**FINDINGS AND RECOMMENDATION
OFFICE OF PLANNING AND ZONING
ANNE ARUNDEL COUNTY, MARYLAND**

CASE NUMBER: 2025-0240-V

REQUEST

The applicants are requesting a variance to allow a dwelling with less setbacks and buffer than required and with disturbance to slopes of 15% or greater on property located at 103 Wallace Manor Road in Edgewater.

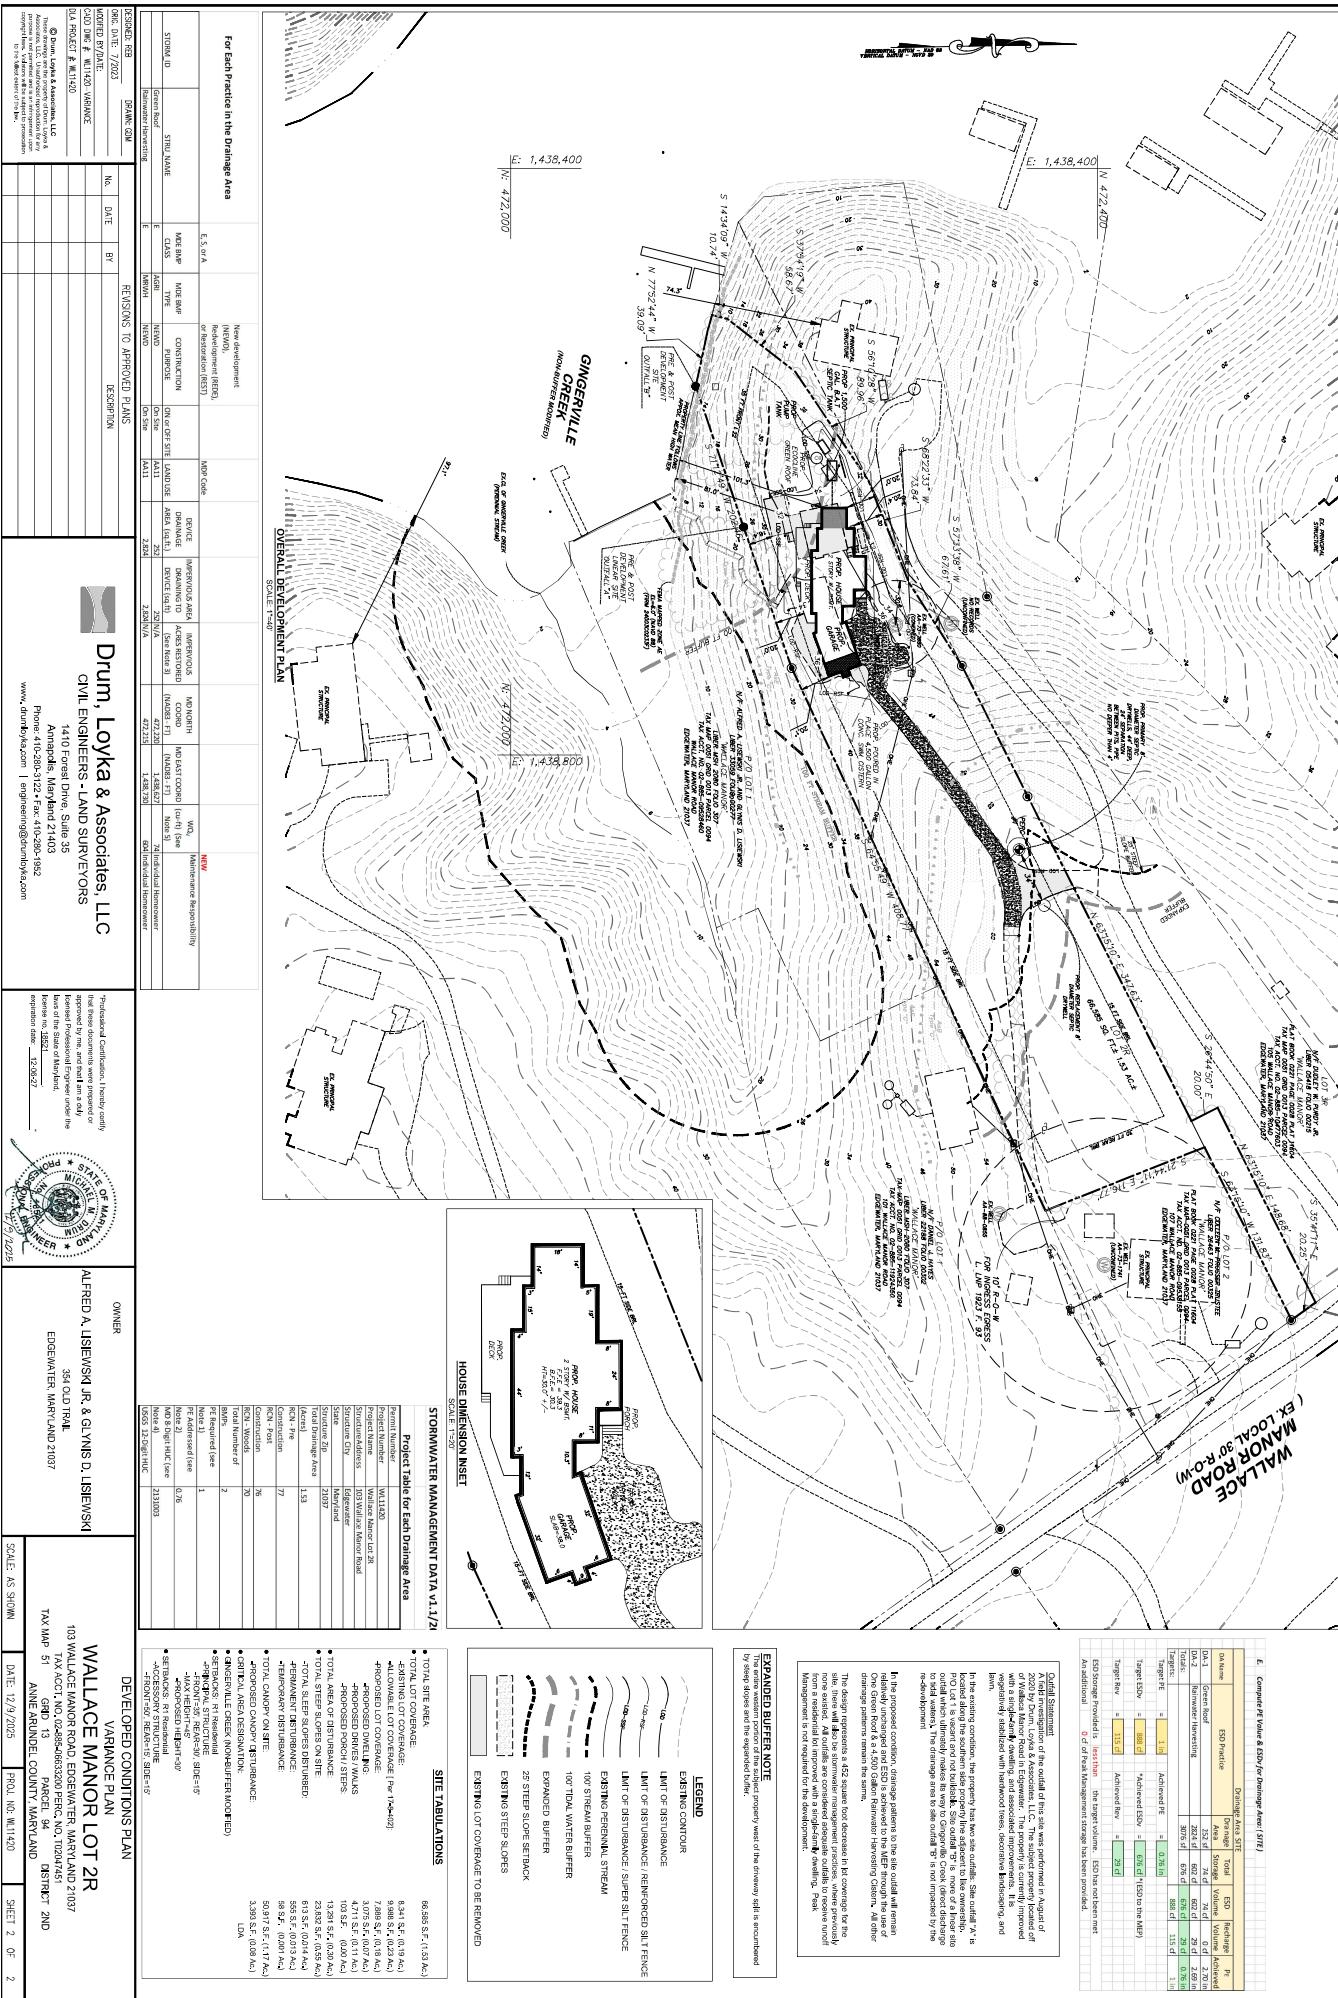
The **Health Department** commented that the minimum separation required between the proposed porch and the existing well have not been met. A minimum separation of thirty (30) feet must be provided to protect the individual well water supply system from a foundation or soil treated to control pests, insects, or vermin. The site plan must show two replacement septic drywells for a proposed demo/rebuild. The Department recommends denial of the variance request.

The Health Department has determined that the minimum separation required between the proposed porch and the existing well have not been met. A minimum separation of thirty (30) feet must be provided to protect the individual well water supply system from a foundation or soil treated to control pests, insects or vermin. The site plan must show two replacement septic drywells for a proposed demo/rebuild. The Health Department recommends denial of the above referenced request.
